AMENDMENT OF SOLICITATION/MODIFICATION OF CONTRACT			1. Contract Number	Page of Pages	
				1	49
2. Amendment/Modification Number	3. Effective Date	4. Requisition/Purchase Request No.		UDC Renovation of David A. Clarke School of Law	
GF-2012-B-0039-002	February 16, 2012

14. Description of amendment/modification (Organized by UCF Section headings, including solicitation/contract subject matter where feasible.)					
Solicitation No. GF-2012-B-0039 for Renovation of the University of the District of Columbia David A. Clarke School of Law is hereby amended as follows:

Amendment 002 – Questions and Answers

5TH FLOOR FRAMING PLAN

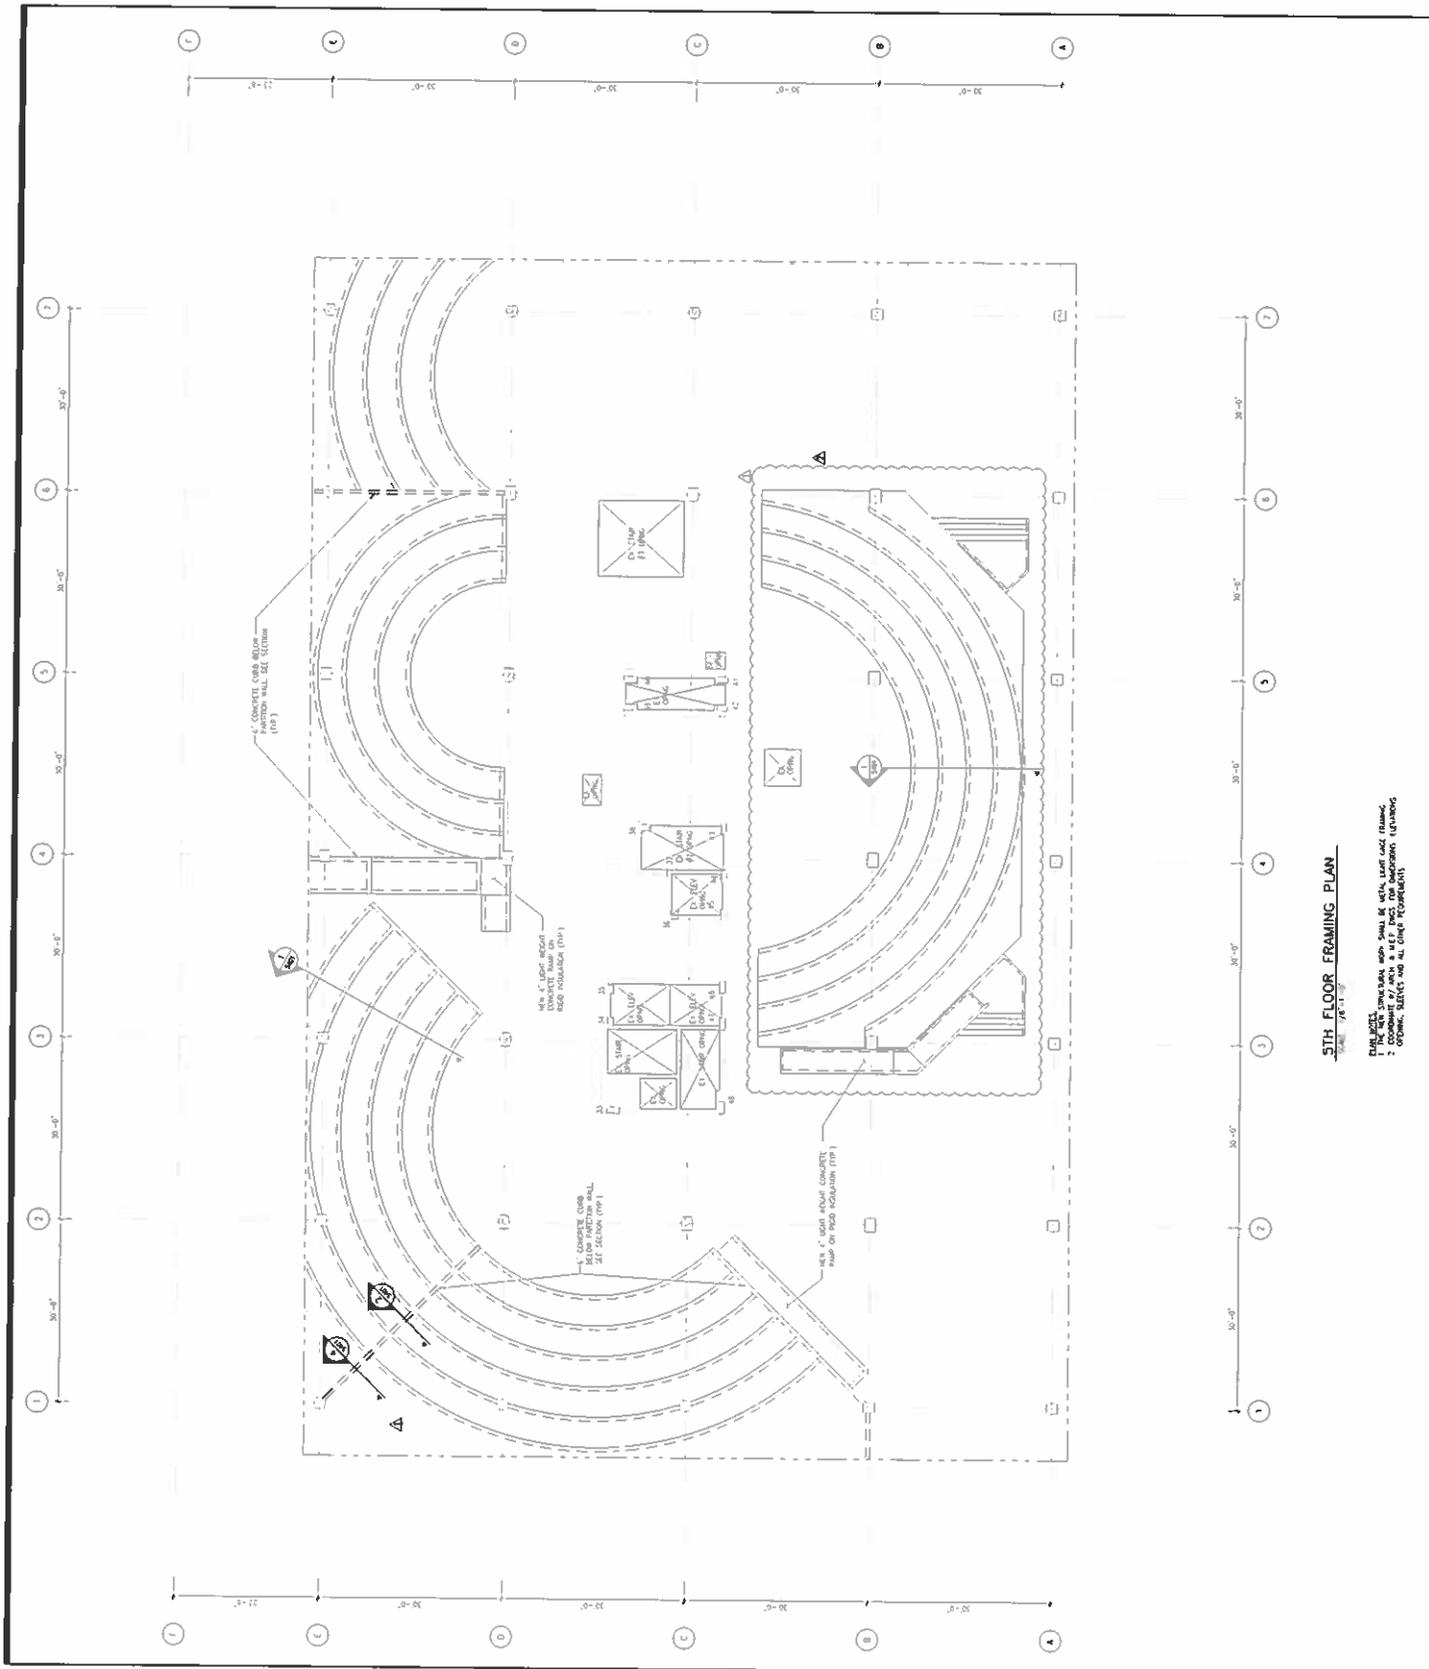
7. Question: We have sheet S-205 "5th Floor Framing Plan" and it is not corresponding to sheet A-105 (i.e., Room 518 shows a tiered flooring and missing raming details in S-205). Please provide us a revised sheet S-205 if floor framing is needed in Room 518.

27. Question: Drawing S205 shows new 4" light weight concrete ramp on rigid insulation (typ.). Drawing A801.1 indicates metal stud, wood framing, batt insulation, and plywood sub-floor ramp at the same locations. Which is correct?

28. Question: Drawing S205 and 2/S401 show 6" concrete curb below the partition wall. Architectural drawing doesn't show any concrete curb. Which is correct?

Answer: **The Amendment #1 shows the final layout of room 518 on sheet A105. Revised sheet S2.05 as issued in Amendment #2 shows the current layout for tiered seating in room 518.**

Answer: **Structural (See revised S2..05 with Amendment #2)**

Answer: **Structural (See revised S2..05 with Amendment #2)**

REFLECTED CEILING PLAN - THIRD FLOOR
Scale: 1/8" = 1'-0"

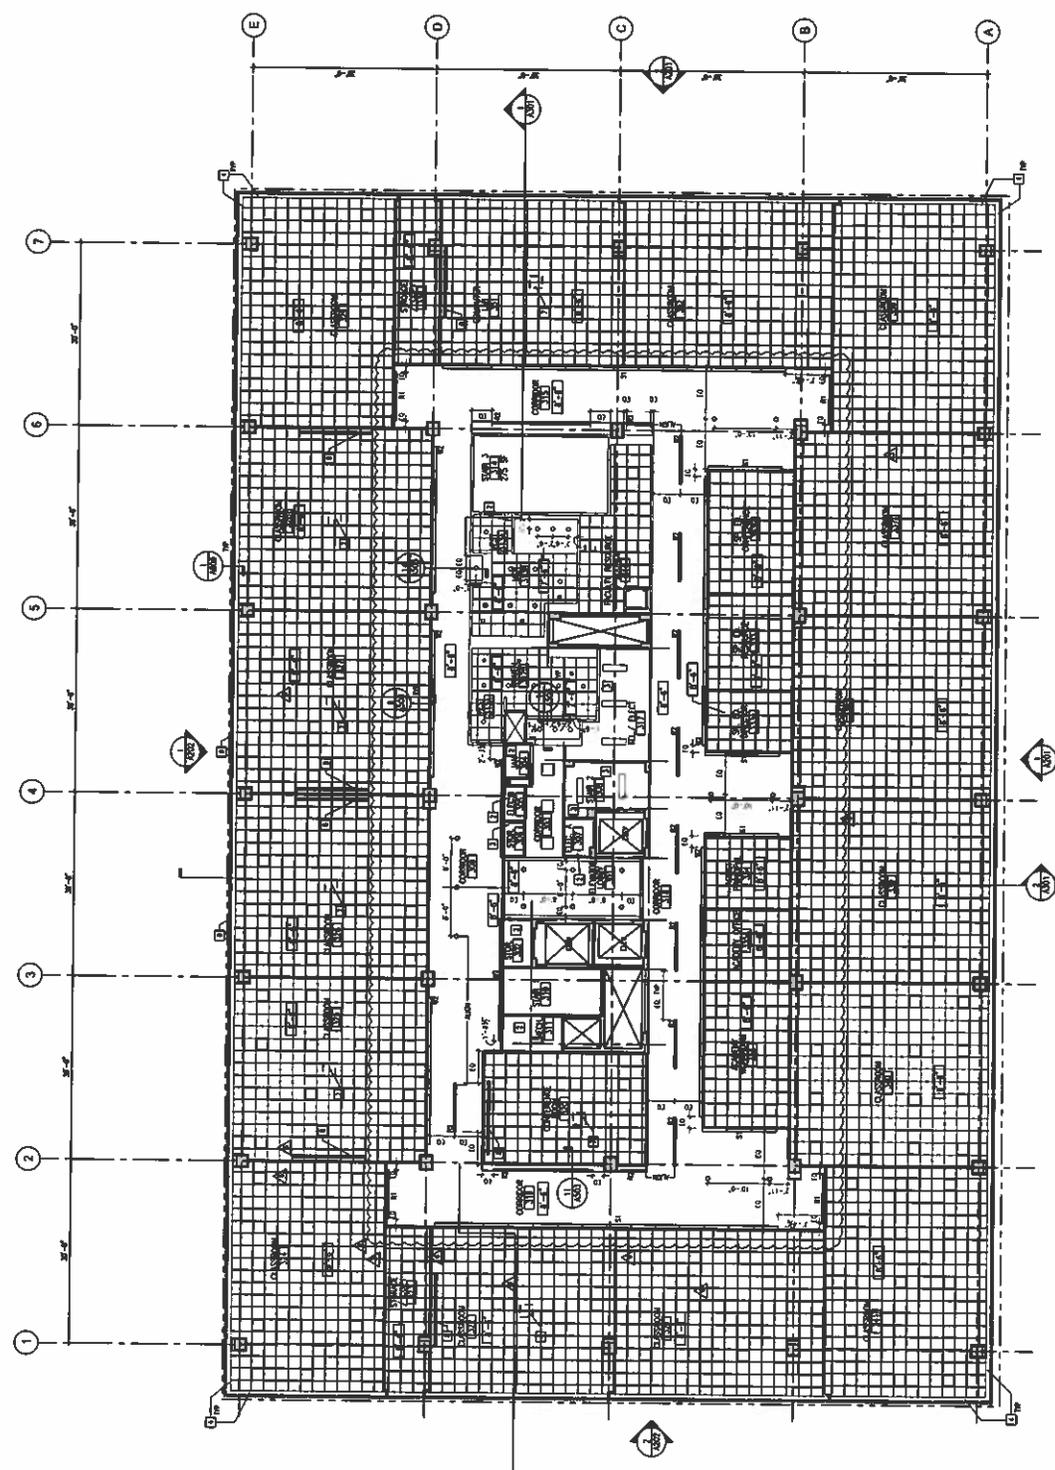
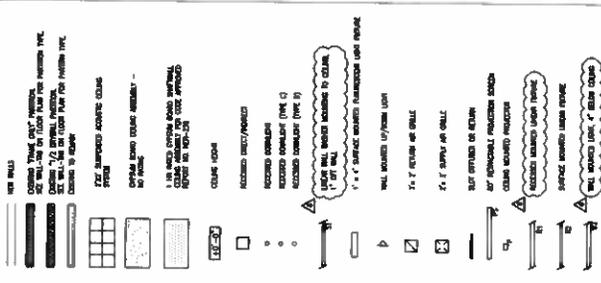
16. Question: Drawing A004, demolition note #27, "*New plumbing lines in third floor clg. (Ref. plumbing dwgs.)*". Please provide the reflected ceiling plan of third floor so we can demo and patch the work accordingly.

Answer: **This information should be field verified by the contractor. The existing corridors have gypsum ceilings with access panels. All other spaces have acoustic lay in ceilings. See attached Third floor plan from previous renovation.**
